Annex A1: Note to Readers

In April 2015, Treasury Metals Inc. (Treasury Metals) submitted an Environmental Impact Statement (EIS) for the proposed Goliath Gold Project (the Project) to the Canadian Environmental Assessment Agency (the Agency) for consideration under the Canadian Environmental Assessment Act (CEAA), 2012. The Agency reviewed the submission and informed Treasury Metals that the requirements of the EIS Guidelines for the Project were met and that the Agency would begin its technical review of the submission. In June 2015, the Agency issued a series of information requests to Treasury Metals regarding the EIS and supporting appendices (referred to herein as the Round 1 information requests). The Round 1 information requests included questions from the Agency, other federal and provincial reviewers, First Nations and other Aboriginal peoples, as well as interested stakeholders. As part of the Round 1 information request process at the request of the Agency, Treasury Metals has consolidated the responses to the information requests into a revised EIS for the Project.

The enclosed document provides the final responses from 1 to 265 of the Round 1 information requests in

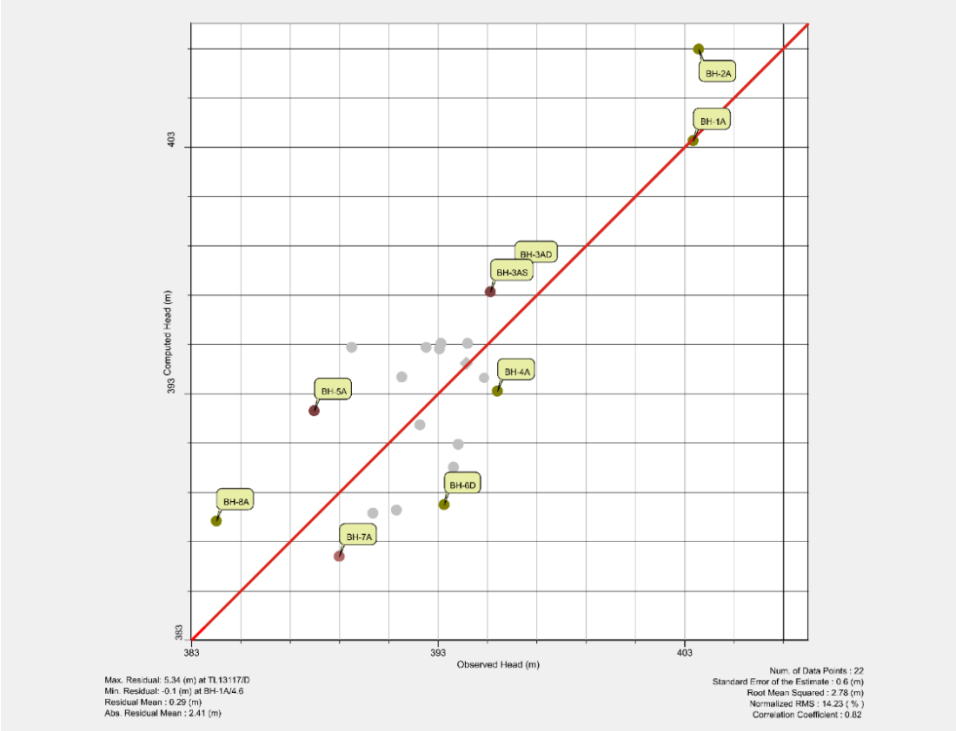
TMI #	Agency Reference #	Parties Asking Questions	Reference to EIS	Reference to EIS Guideline	Comment / Information Request / Response
71	GW(1)-08	CEA Agency	Appendix M Section 3.1.1, Figure 4	Section 9.1.2	<p>Summary of Comment / Rationale:</p> <p>A good understanding of the surficial geology of the area around the proposed pit is essential for both hydrogeological modelling and site layout purposes.</p> <p>The surficial geology map shown in Figure 4 (Appendix M) is erroneous for the area surrounding the proposed pit and along the perimeter of the drawdown zone. For example, the map shows glaciolacustrine sediments in an area where the proponent mapped a series of bedrock outcrops. Moreover, the map differs considerably from that of Cowan and Sharpe (1991) cited by the proponent, which appears to be more accurate in many respects. The missing surficial units may play a key role on groundwater recharge and flow.</p> <p>Information Request / Comment:</p> <p>A. Update Figure 4 (Appendix M) (i.e. the map of surficial geology of the project site and, at a minimum, the area of the drawdown cone and its perimeter). Based on the updated figure, make necessary changes to the discussion and analysis in subsequent sections of the EIS and supporting documents.</p> <p>B. Update conceptual model, groundwater recharge, flow model, etc. based on the revised surficial geology information.</p> <p>Response:</p> <p>Since the publication of both the Cowan and Sharpe (1991) and the Roed (1980) surficial geology maps the following additional data has become available, or been collected by Treasury Metals:</p> <ul style="list-style-type: none"> • The water well records from wells drilled after publication of these maps (note these have occurred around Thunder Lake and Wabigoon are not a significant addition to areas immediately around the proposed Goliath open pit). • The Beakhouse and Pigeon (2003) map, which has delineated locations of bedrock outcrops (shown on Figure 4 of Appendix M to the revised EIS), and has provided some localized comments on sediments at surface. • Bedrock outcrop mapping undertaken by Treasury Metals in the immediate vicinity of the proposed Goliath open pit (shown on Figure 4 of Appendix A of Appendix M to the revised EIS). This information is taken to be more accurate than the outcrop location data from Beakhouse and Pigeon (2003) and is used in preference where mapped as indicated on Figure 4 of Appendix M to the revised EIS.

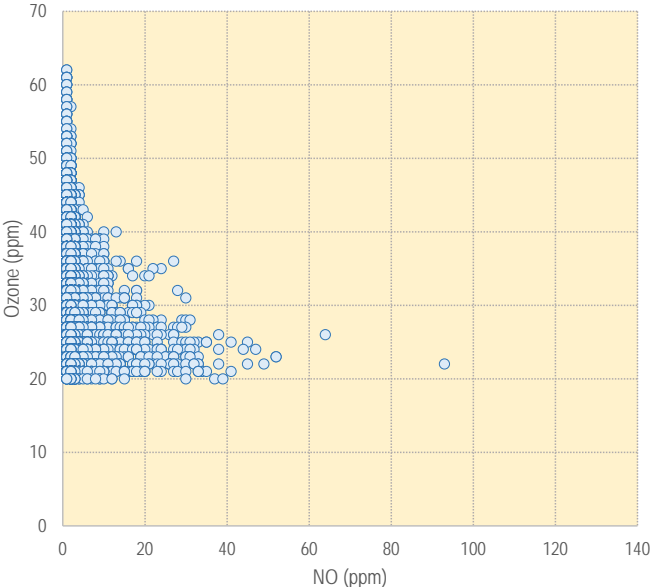
C. Table 10 provides a summary of Ecosite information by major habitat types (Coniferous, Deciduous, Succession, Wetland, and Upland).						
					Table 10: Summary of Ecosite information by major habitat.						
					Habitat Category	Area (km²)					
						RSA	LSA	Project Footprint			
					Conifer	779.08	16.09	1.18			
					Deciduous	697.04	7.30	0.79			
					Successional	226.93	3.20	1.03			
					Upland	95.53	.091	0.00			
					Wetland	401.64	14.07	0.33			
					Developed	251.57	3.57	0.95			
					Totals	2,451.79	45.13	4.27
